A Plus Sweater LTD.

Sarifpur Road,(Maleker Bari) P.O. National University, Gazipur Sadar, Gazipur
(23.966094N,90.377113E)
22th September 2016

Observation

Provided Column layout

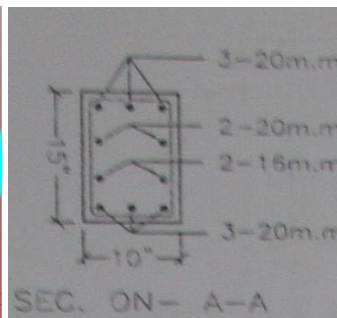
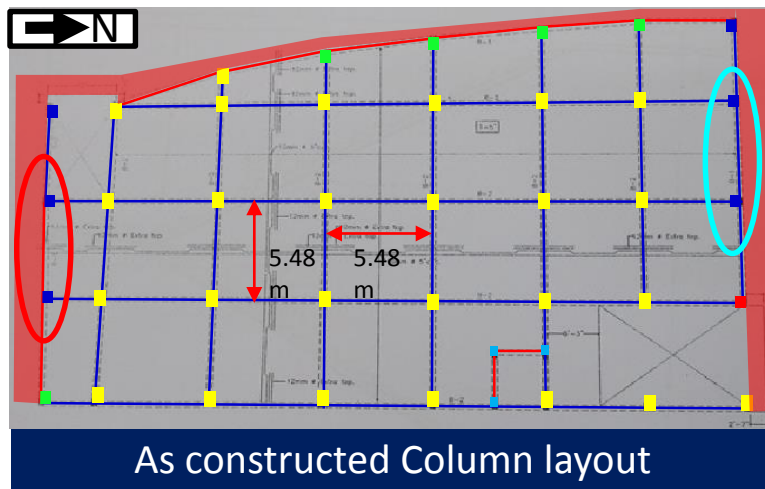
Discrepancies between provided drawing and as built condition

Column schedule for "Red" colour circle column

As constructed Column layout

Column schedule for "Aqua" colour circle column

Column reinforcement did not match with schedule for the marked column

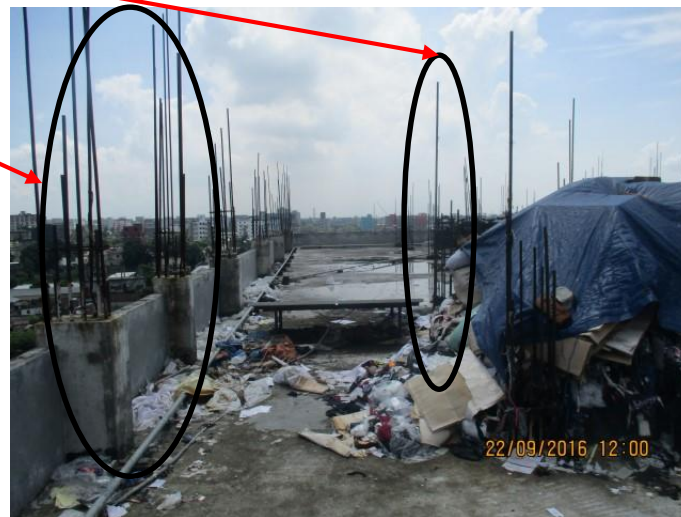
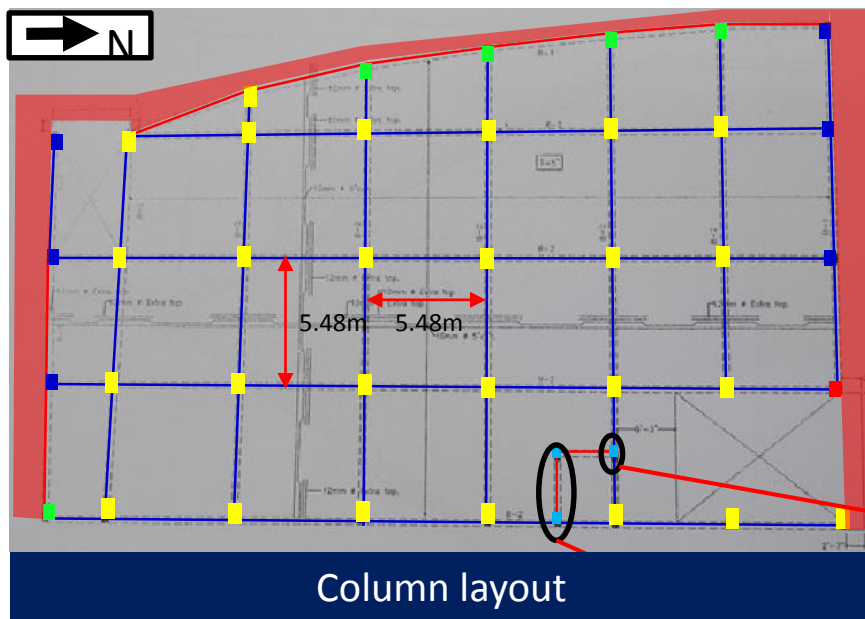
In structural drawing, no column or beam schedule were present for the marked column and beam. Also the cantilever was absent in provided drawing.

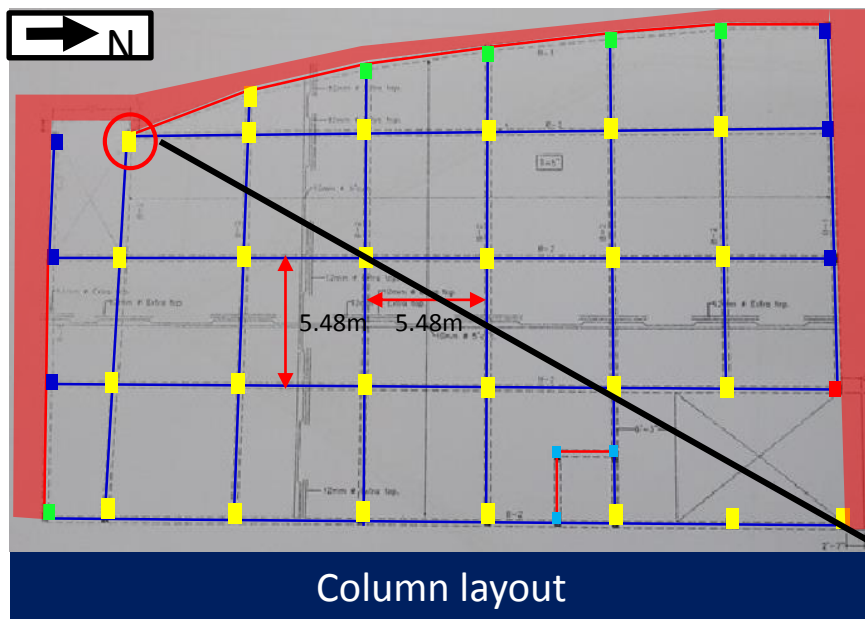
Eccentric beam column joint found adjacent with south stair side

Typical floor layout

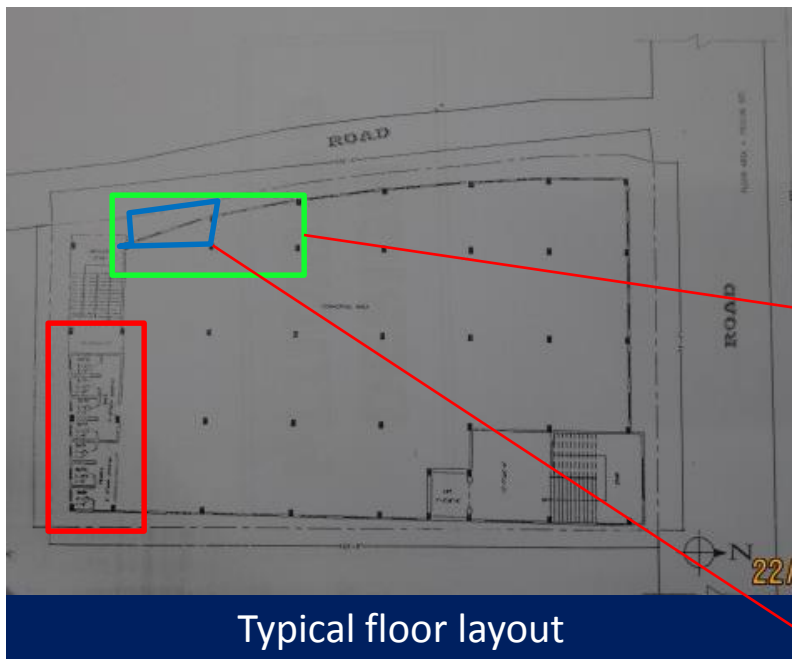
In floor layout plan, the toilet area did not match with provided drawing, also a small mezzanine floor was found over ground floor just beside the south side stair case

Excessive column stresses in fully completed building (6 storeys)

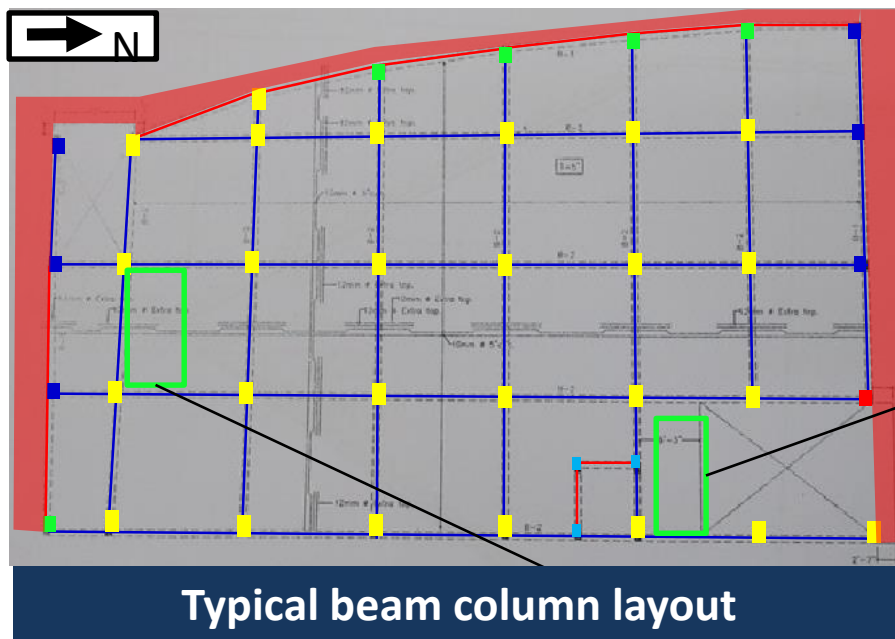
Exposed reinforcement on roof top and building permission for 6 storey indicate a sign of further extension of the building. For any future extension it may cause a significant increase in column stresses which would be required to be carried out Detail Engineering assessment.

Cracks on 3rd floor Slab

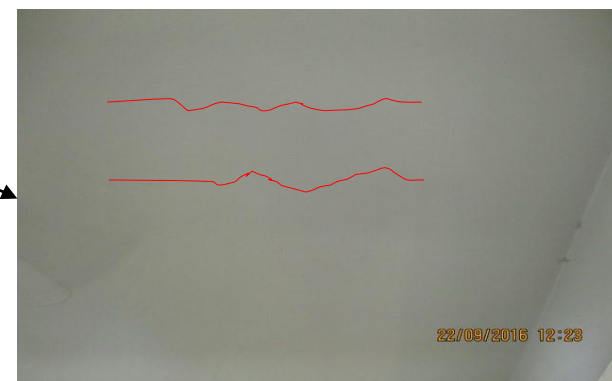
Cracks under the slab
beside north side
stair case

Cracks on slab below the
water tank

Water ponding on roof slab

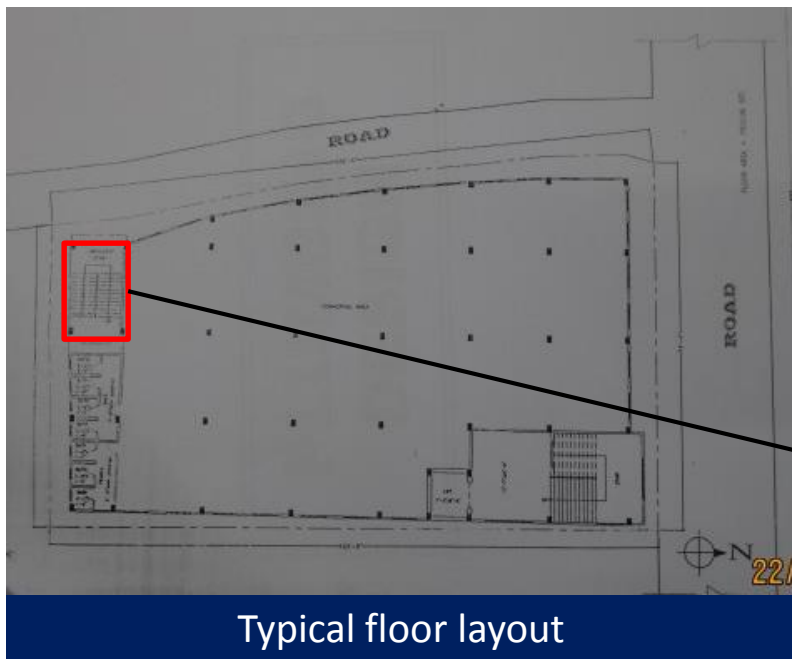
Water ponding was found in almost all over the roof area
